NACELLE - STARTING - AIR SUPPLY DUCT- ALIGNMENT MARK - ALTERATION OF - CATEGORY CODE 4  
- MOD.NAC-80-0006

V2500-NAC-80-0006

TO REPOSITION ALIGNMENT MARK ON UPPER DUCT (Starter system)  
Fig.1

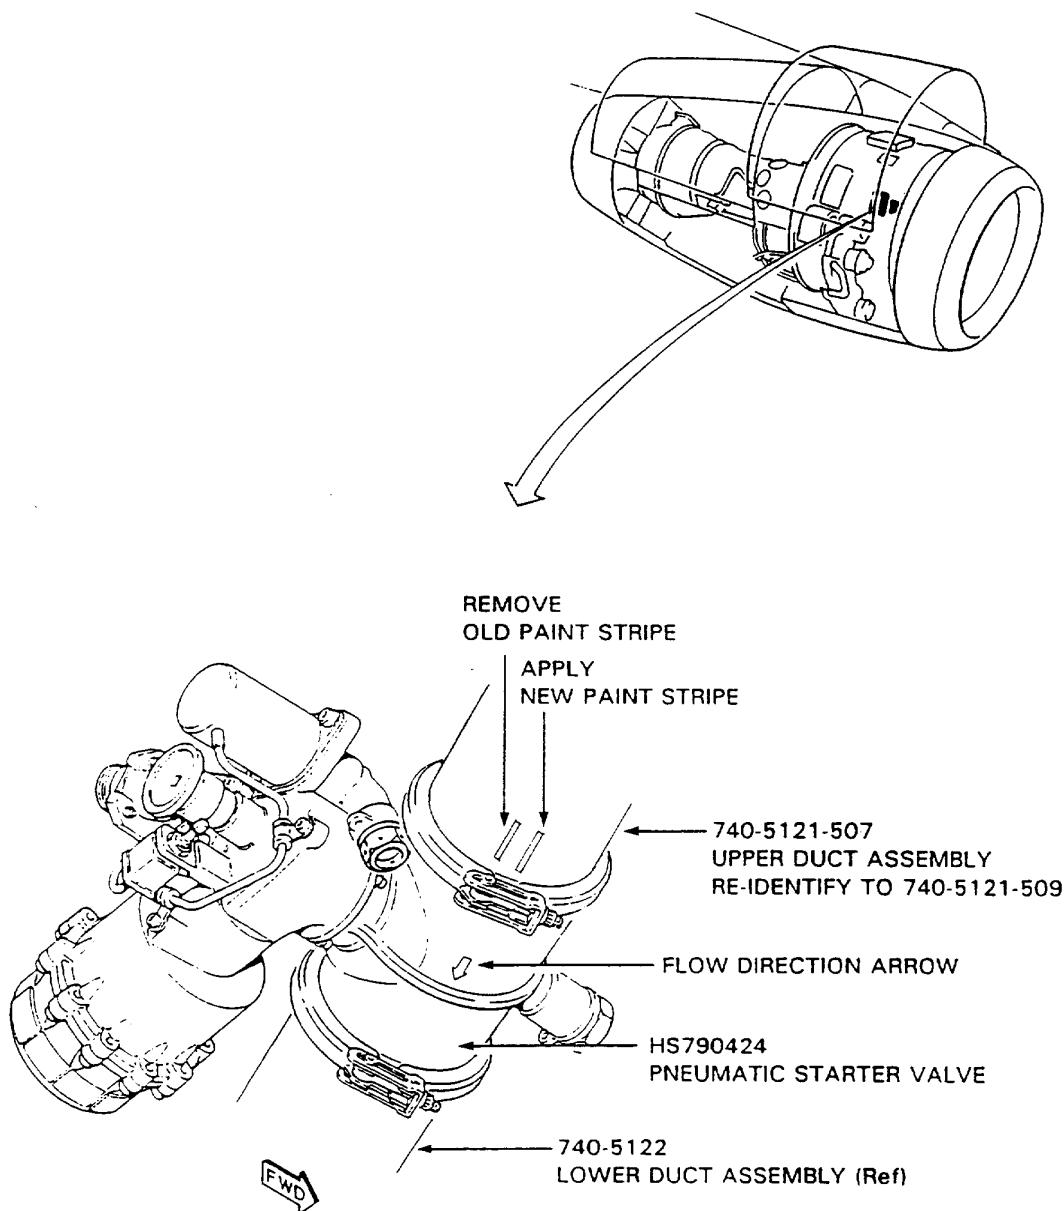
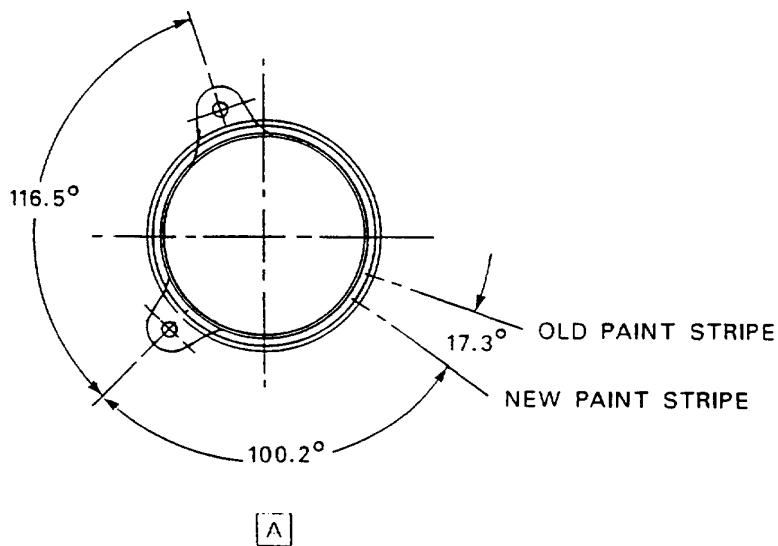
A new pneumatic starter valve has been introduced which has a repositioned electrical connector. To ensure clearance with the Fan cowl door the starter valve has to be rotated slightly, thus offsetting the alignment mark with the upper starter duct.

A new alignment mark is painted on the upper starter duct to line up with the flow direction arrow/alignment mark on the pneumatic starter valve. The old alignment mark on the upper starter duct is then removed.

- (1) Open the right hand fan cowl door as specified in the A320 Aircraft Maintenance Manual, Task 71-13-00-010-010.
- (2) Find the paint stripe/alignment mark on the 740-5121-507 upper duct assembly at the HS790424 pneumatic starter valve. (Refer to figure 1.)

- (1) Make a paint stripe on the 740-5121-507 upper starter air supply duct at 100.2 deg from the lower mounting lug of the duct (approximately 0.6 inch (15.2 mm) from the old paint stripe ). (Refer to Figure 2.) Make sure the new stripe lines up with the stripe on the stater valve. (Refer to Figure 1.)
